RE: Indaver Ireland Application for a Waste Licence for the Carranstown Waste Management Facility

Objection to a Proposed Decision in accordance with Section 42(2) of the Waste Management Acts, 1996 to 2003.

EPA Reference No. 167-1

Objection to a Proposed Decision For A Waste Management Facility Including A Non-Hazardous Waste Incinerator

- Bord Gais map indicating gas main
- Bord Gais map indicating wayleave
- Bord Gais Consent Form indicating appropriate permanent wayleave & working strip (including wayleave)

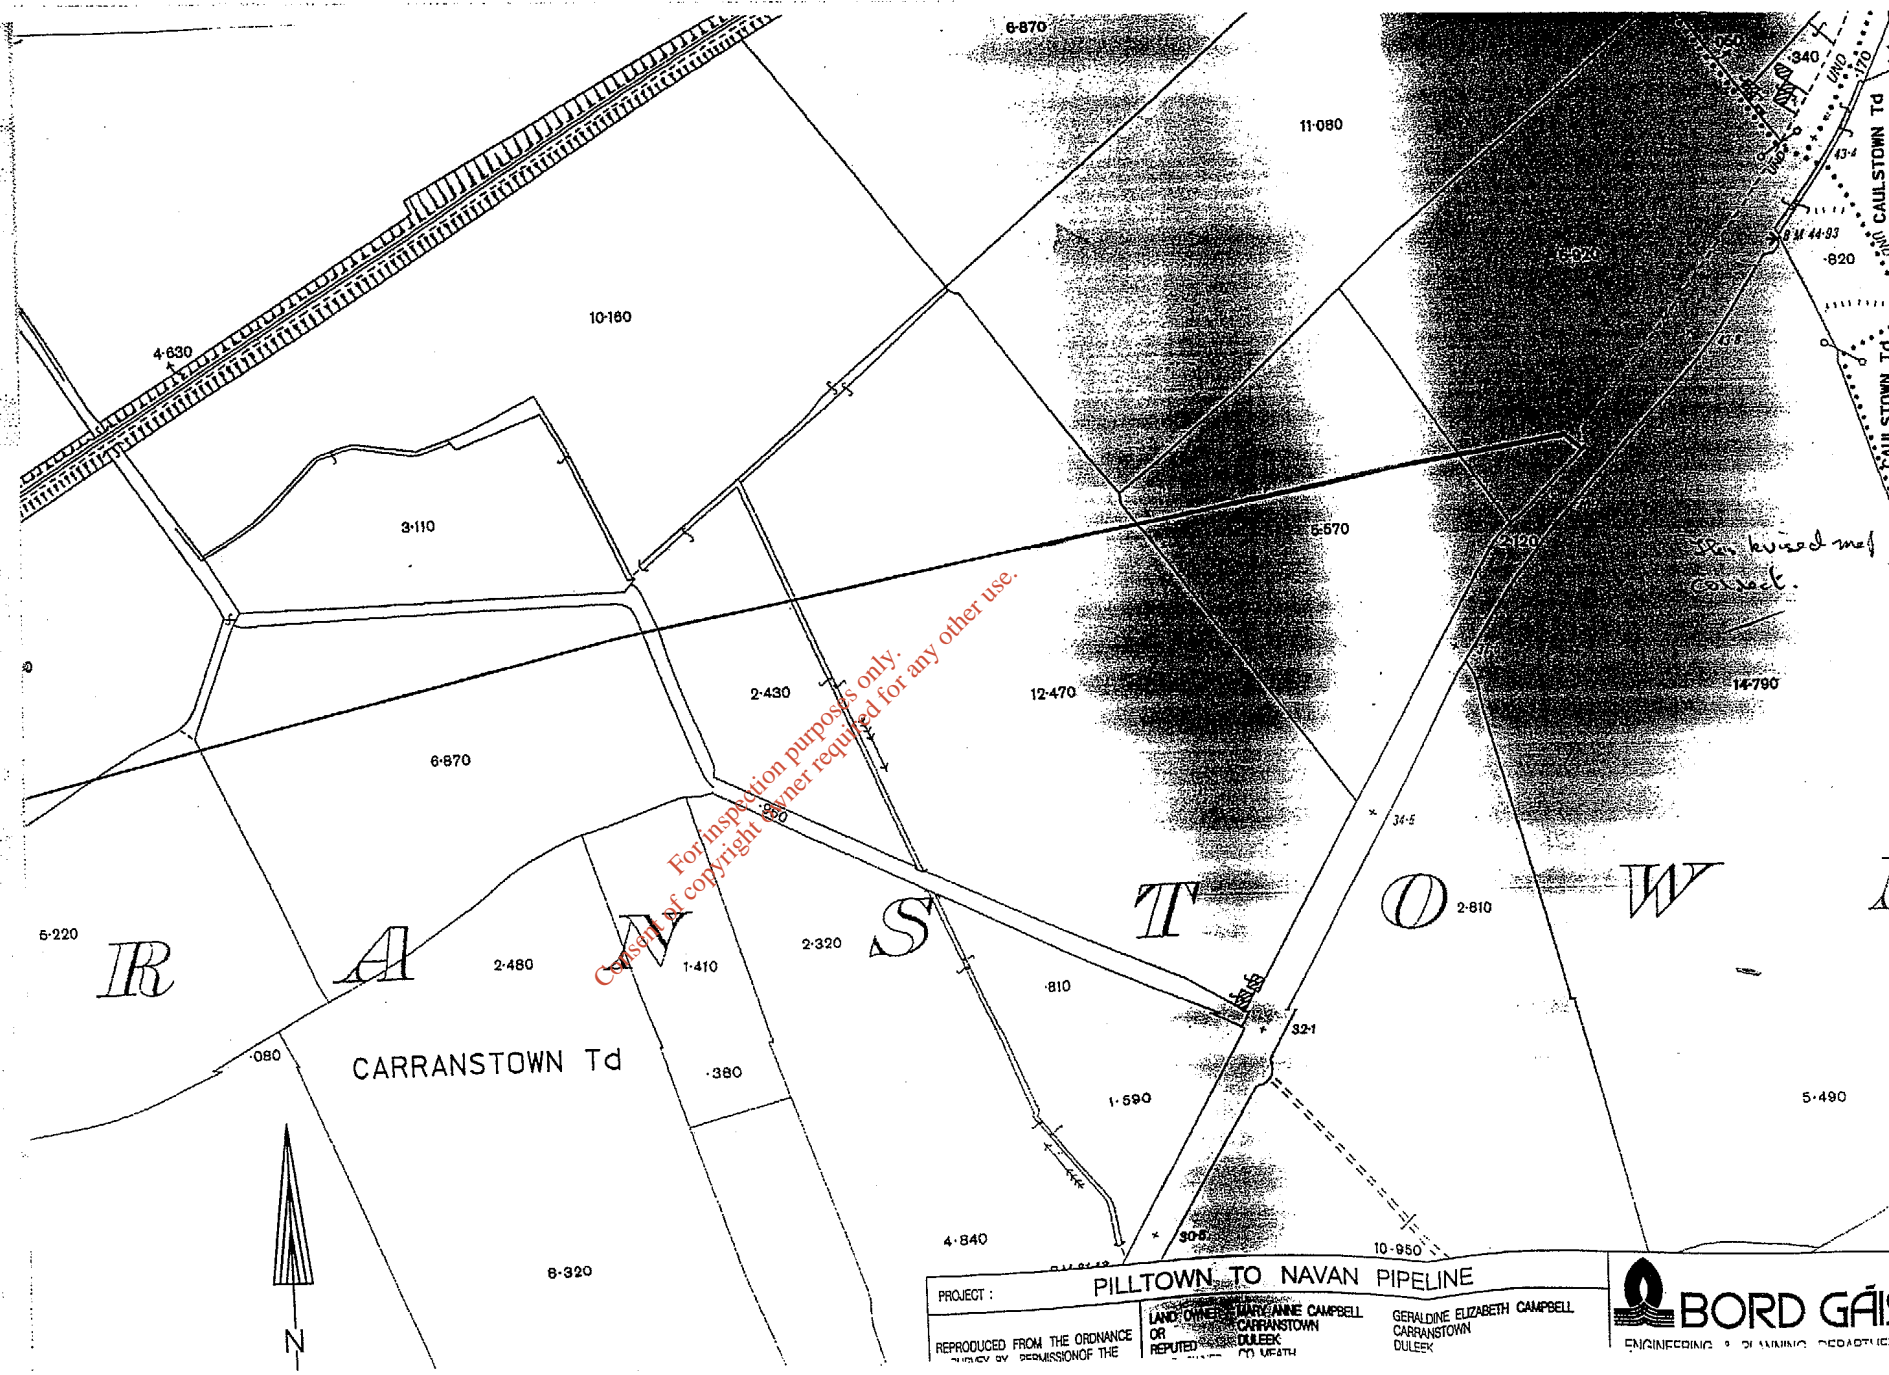
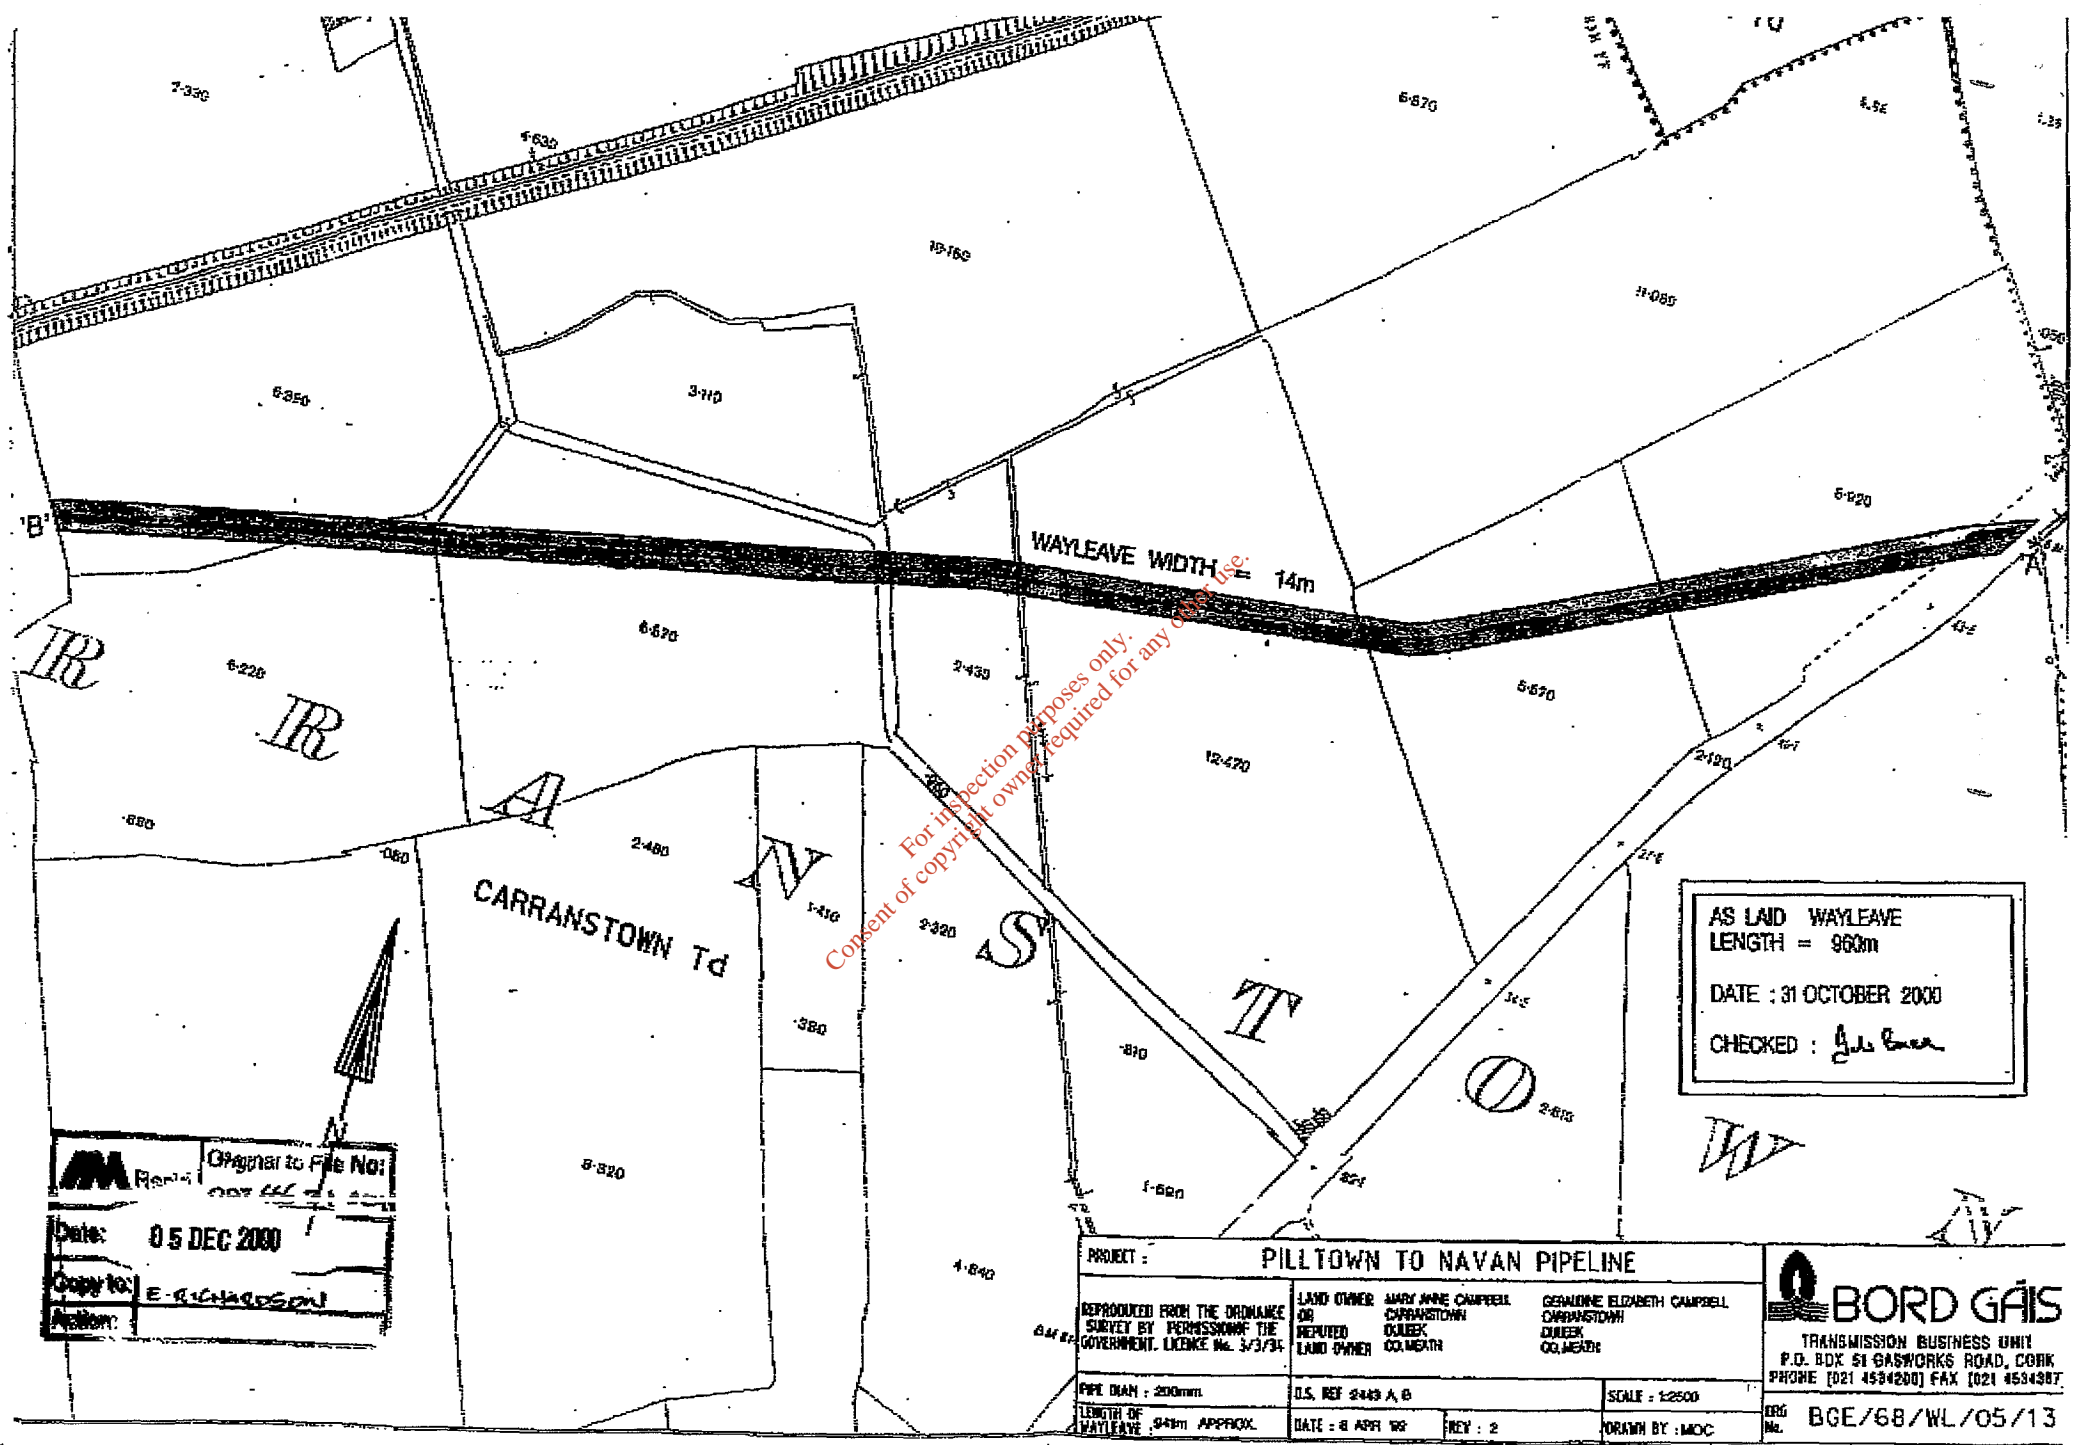
Condition 3.15 requires a 40m way leave to be maintained for the gas main which crosses the site. This width is based on the application which contained an error with regard to the way leave width. Bord Gáis has required a permanent way leave total width of 14m, that is, a width of 7m either side of gas main. During construction of the pipeline Bord Gais required a working strip total width of 18m. The gas main is 300mmm diameter. A copy of Bord Gáis maps and landowner consent form is attached in Appendix 1.

*See revised map
correct.*

- 3.15.1 The pathway for the existing 300 mm diameter gas main shall be clearly delineated on site. An on site way leave that provides a minimum width of 7 metres either side of the mains shall be provided by the licensee.
